PLAN AND PROFILE OF PROPOSED STATE HIGHWAY

PRINCE WILLIAM PARKWAY INTERCHANGE AT REALIGNED BALLS FORD ROAD

VDOT Proj.No.6234-076-266

Notice of Design Change (NDC) #02
JUNE 2021

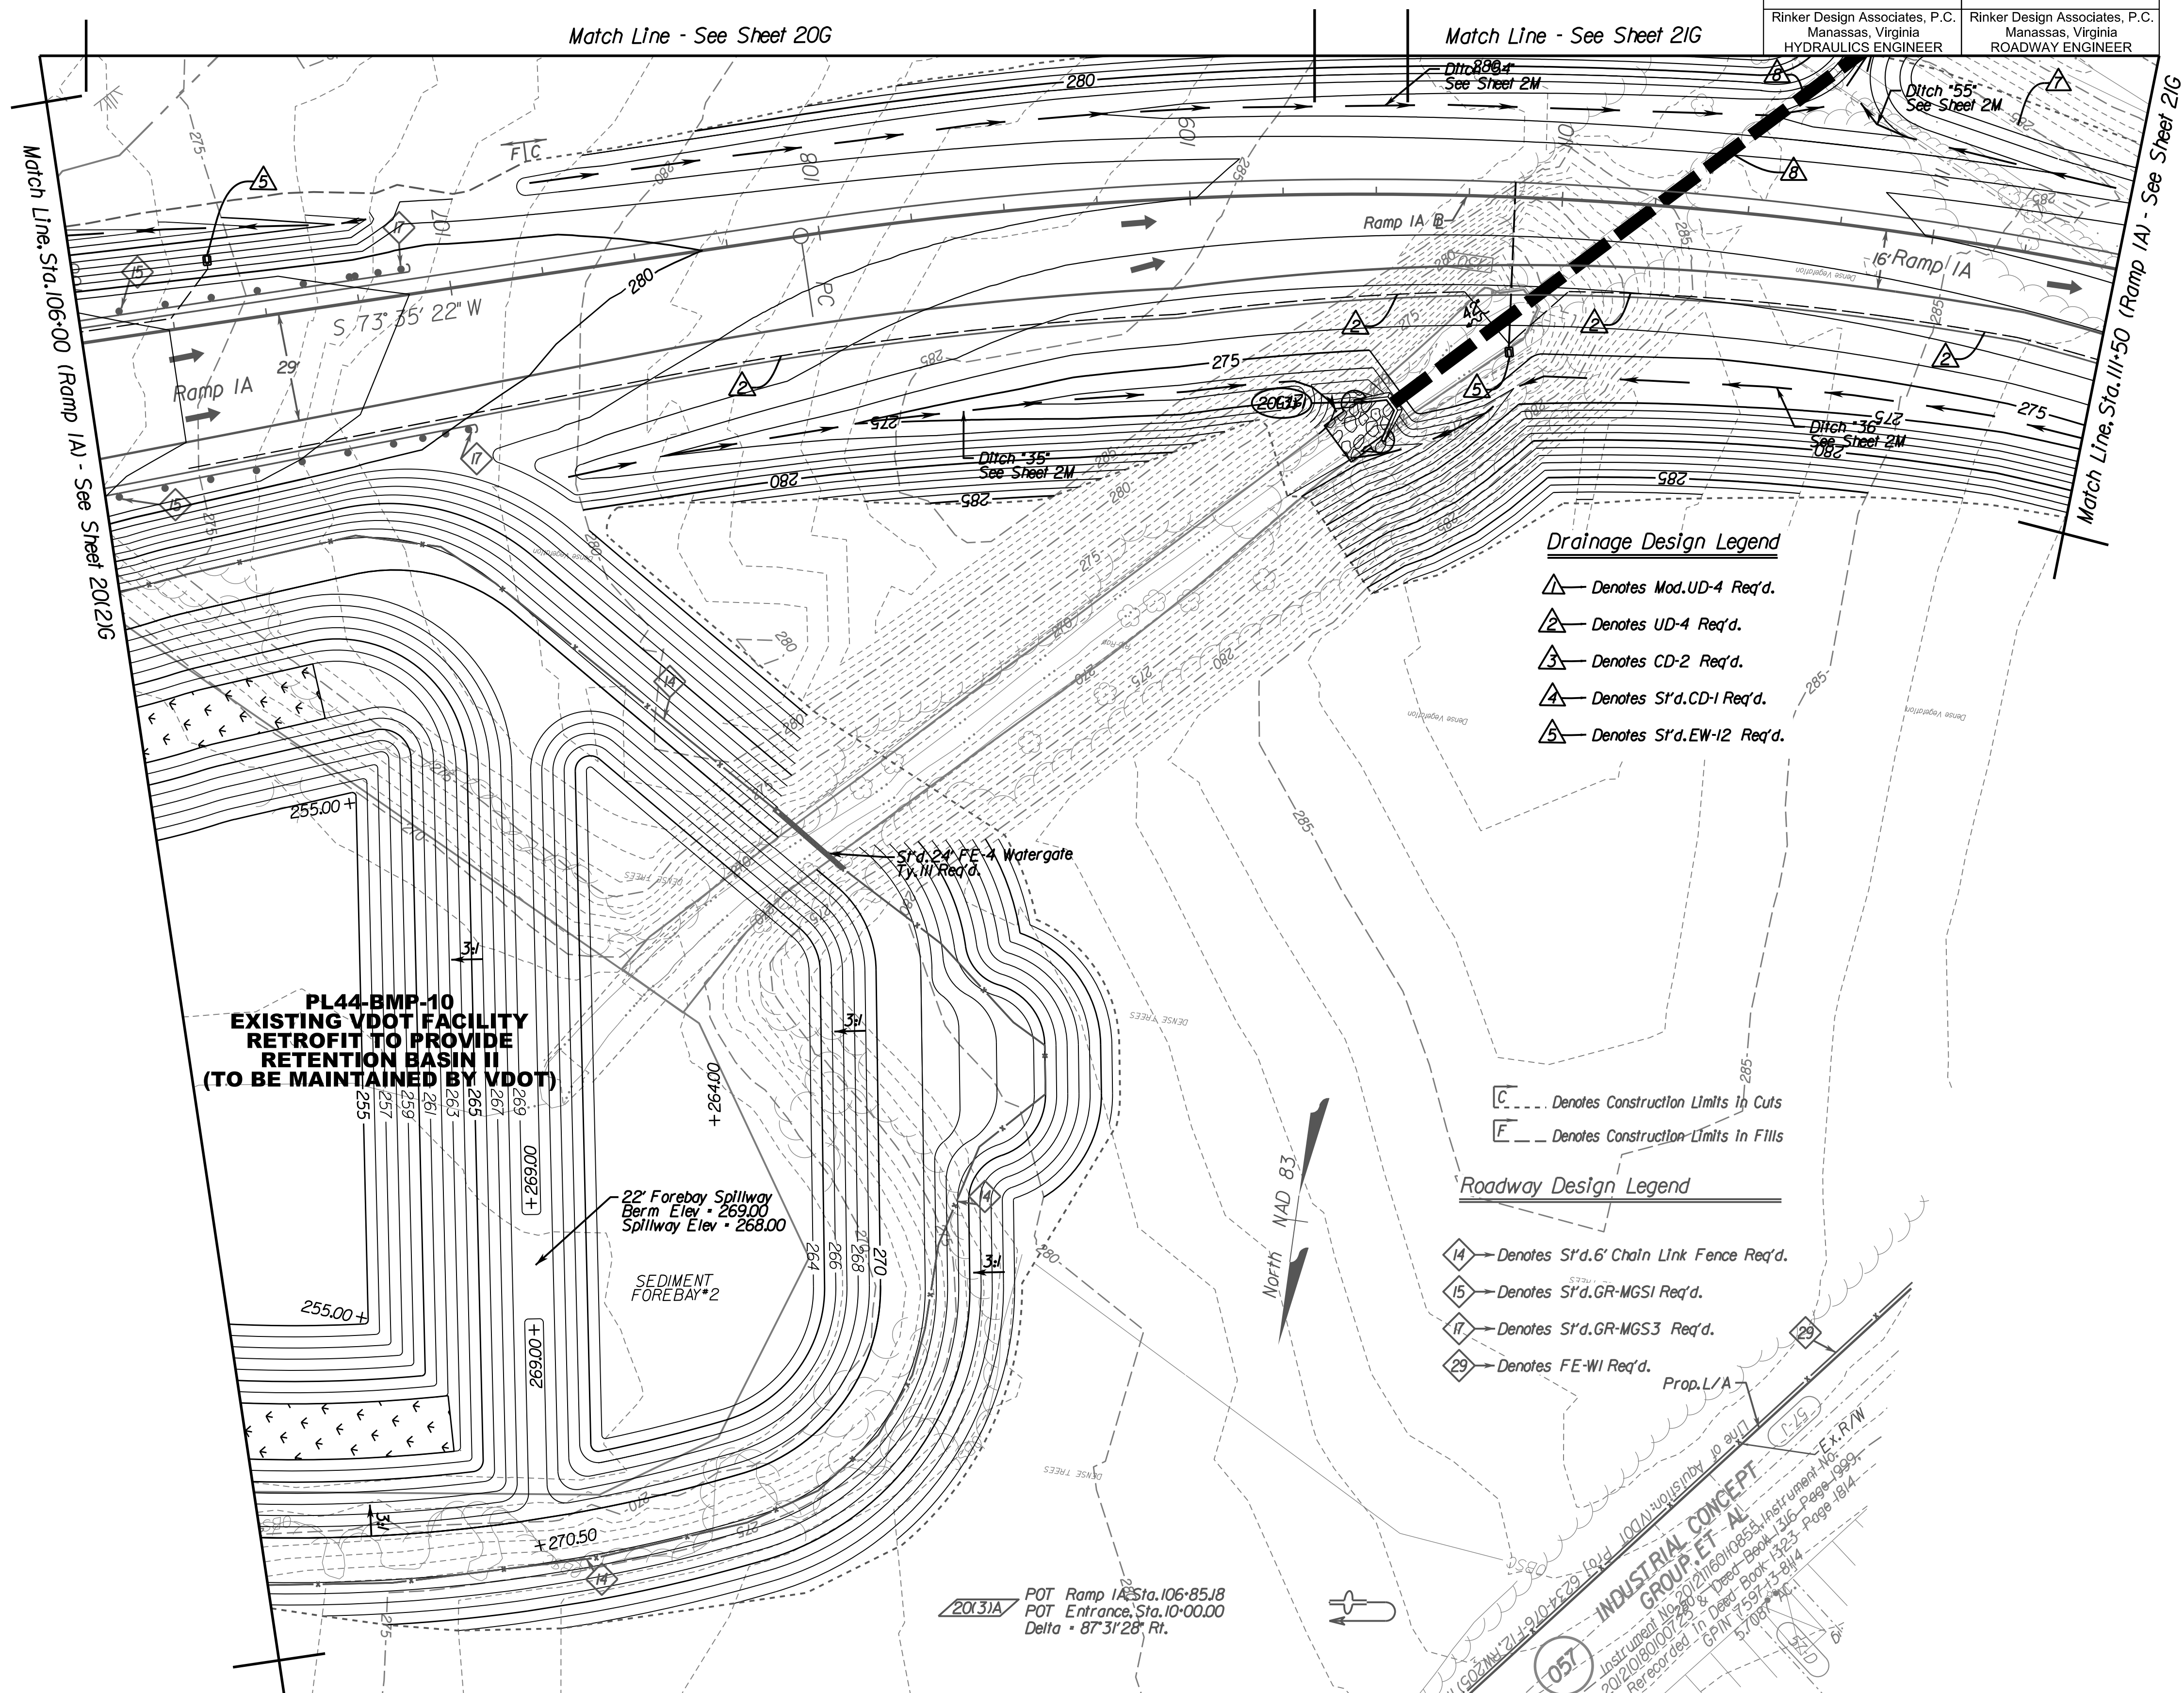
02 Added storm pipe 20(3)-1 to 20(3)-2. Removed 20(3)-3. Realigned ditches around 20(3)-2. Revised grading around 20(3)-2.

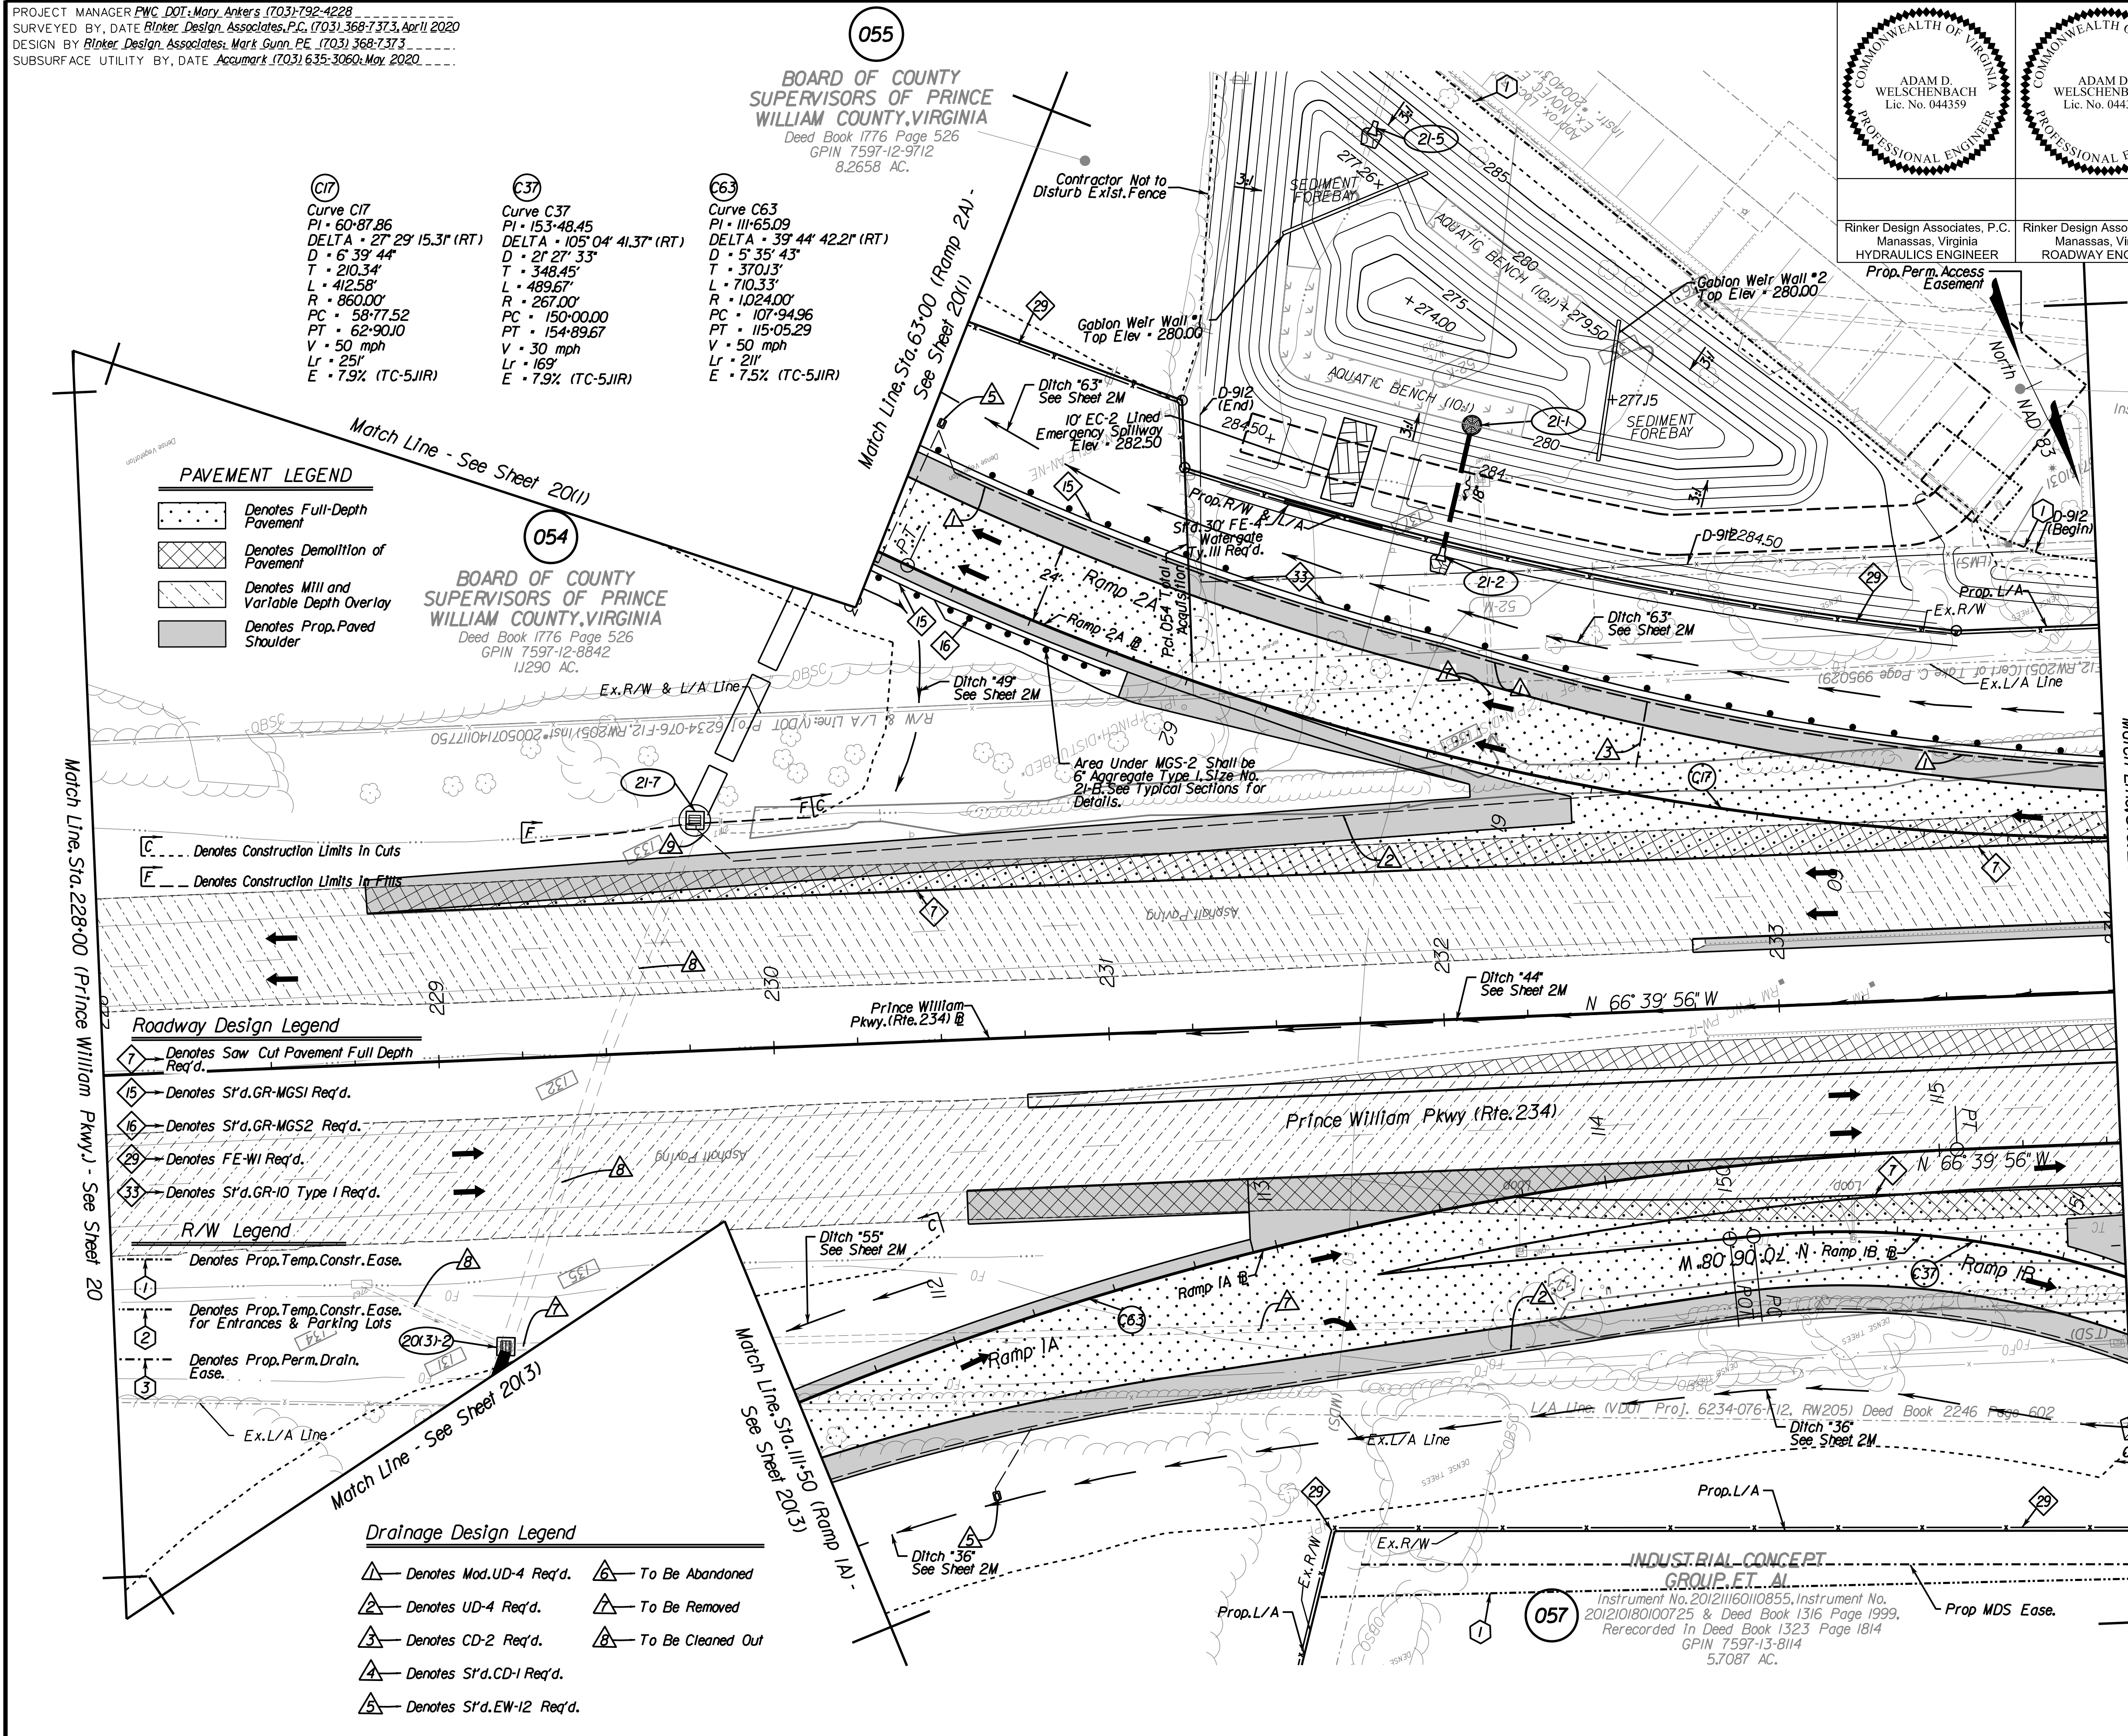
- Added MDS Easement to Parcel 052.
- Removed MDS Easement from Parcel 052. Added MDS Easement to Parcel 057.
- Moved 20(3)-2. Added note to contractor. Removed 299' of fence from Parcel 052.

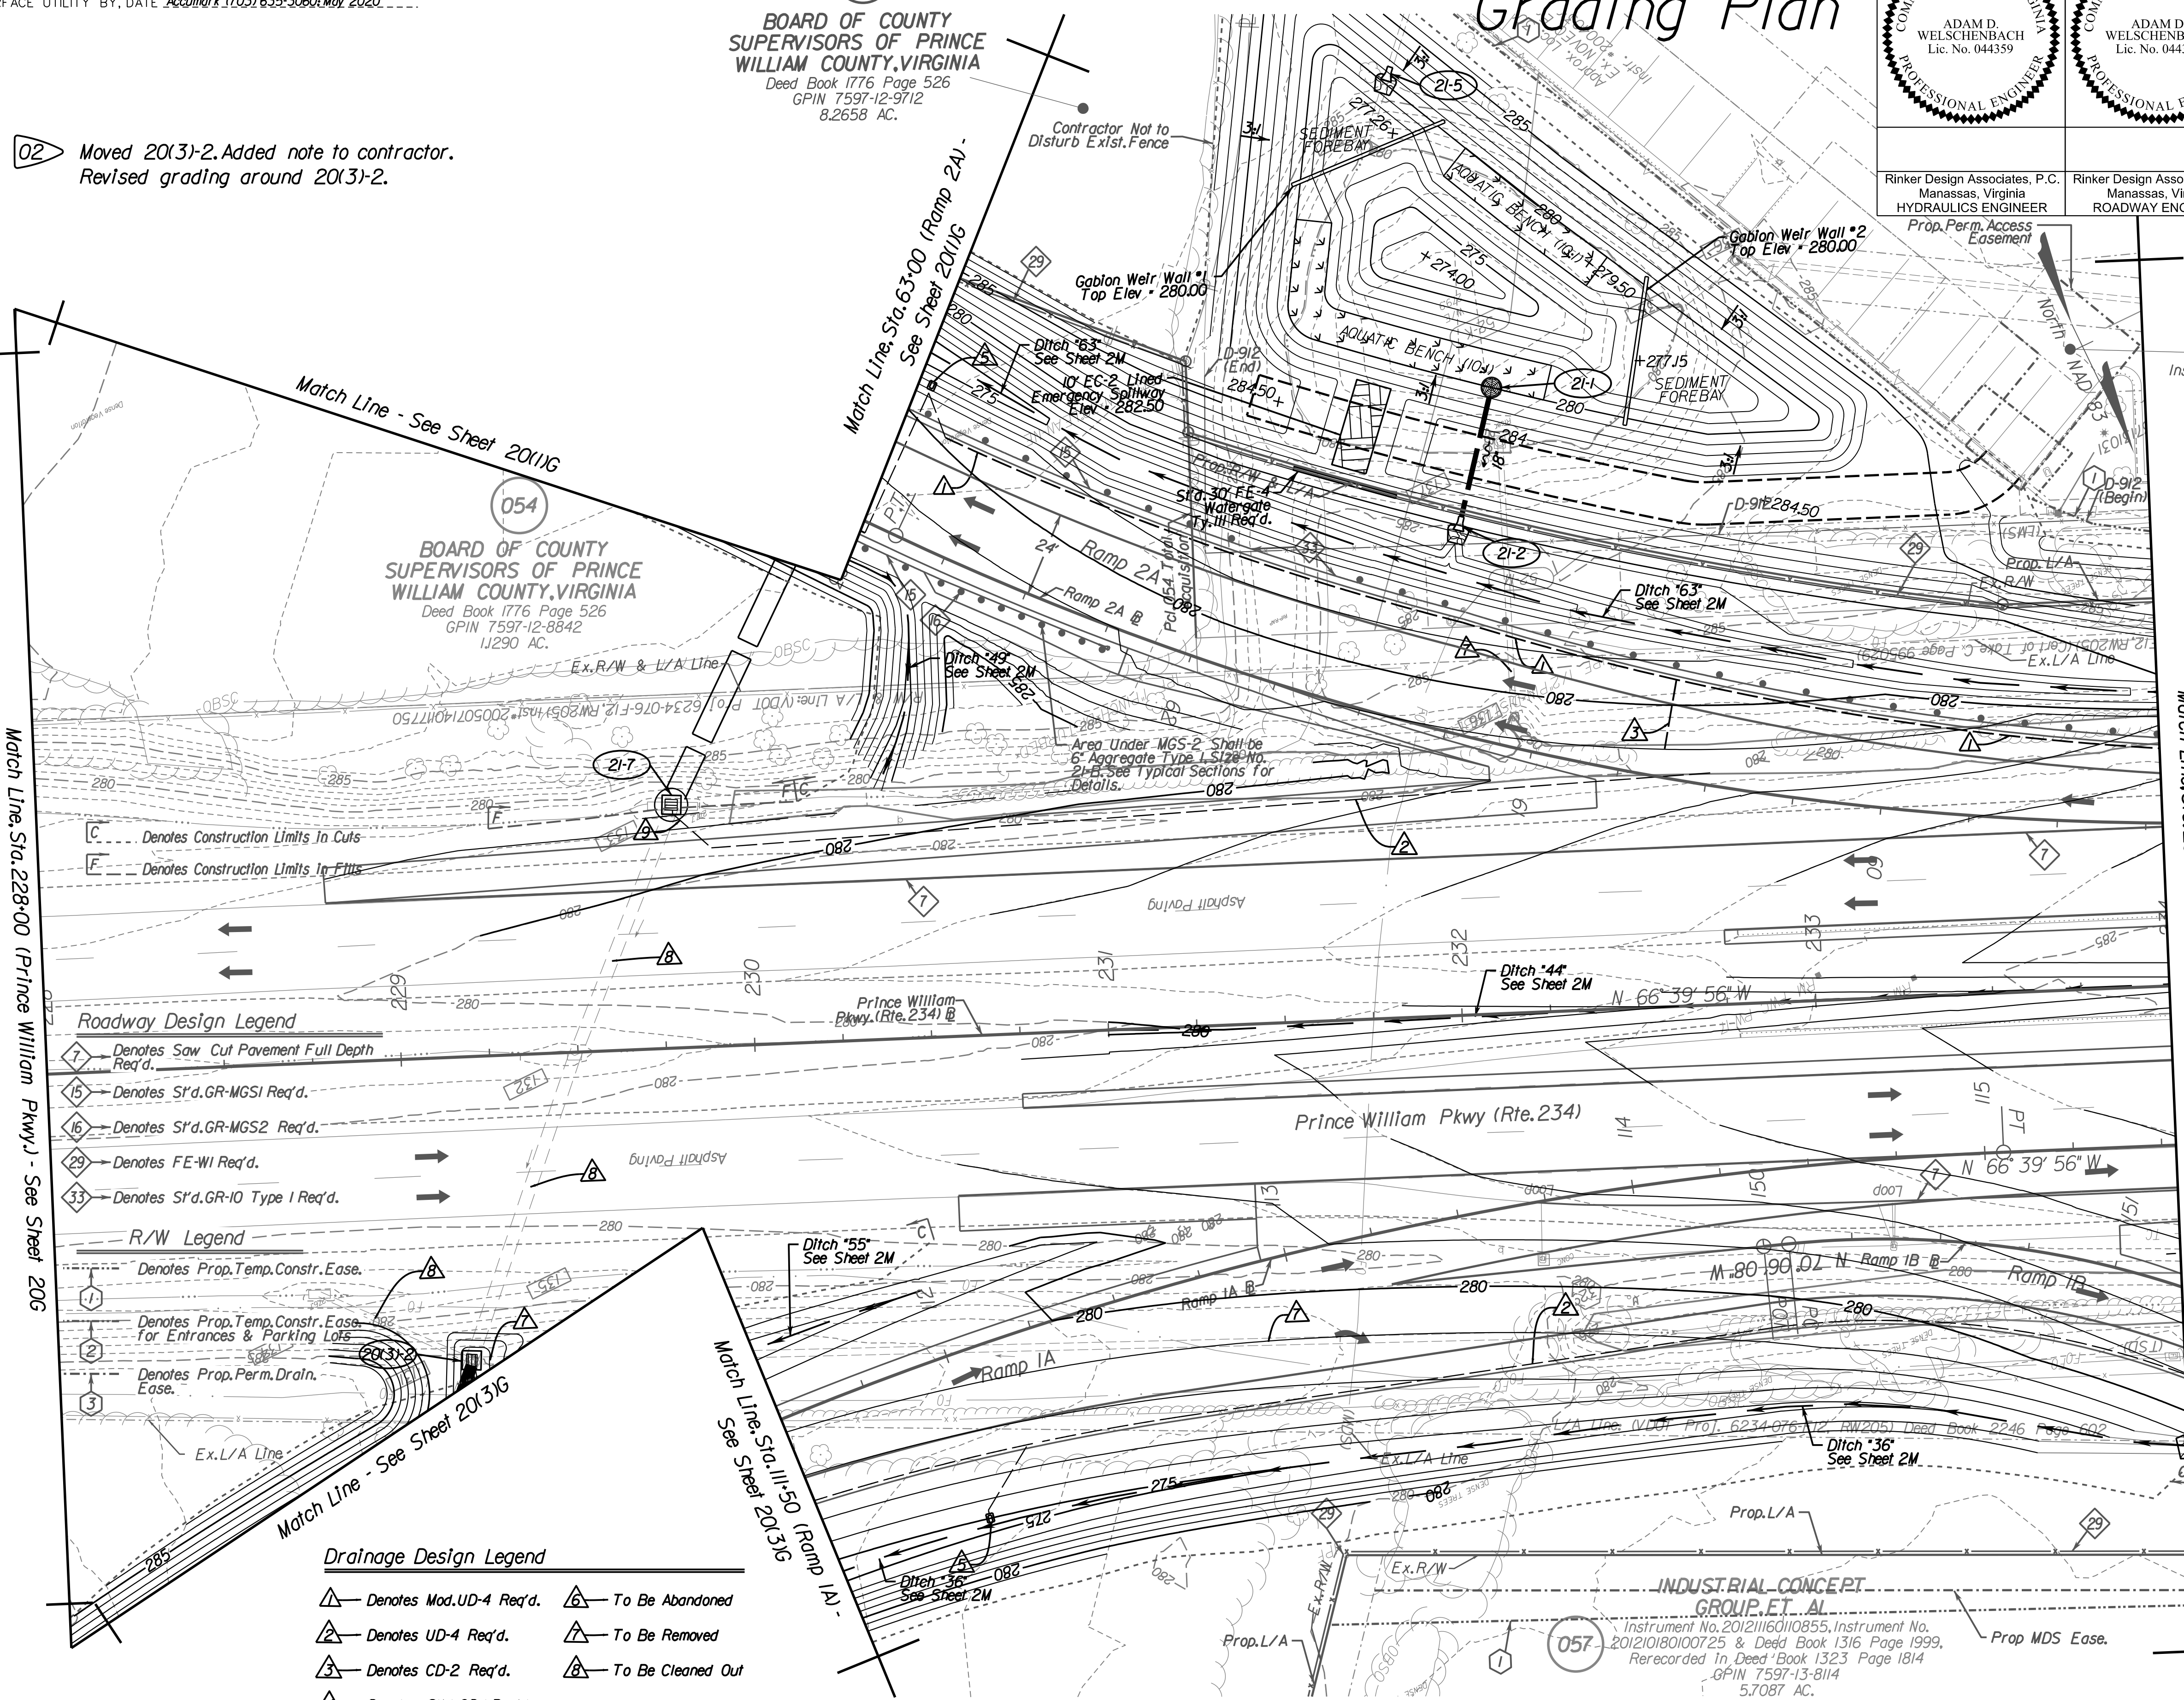
02 Moved 20(3)-2. Added note to contractor. Revised grading around 20(3)-2.
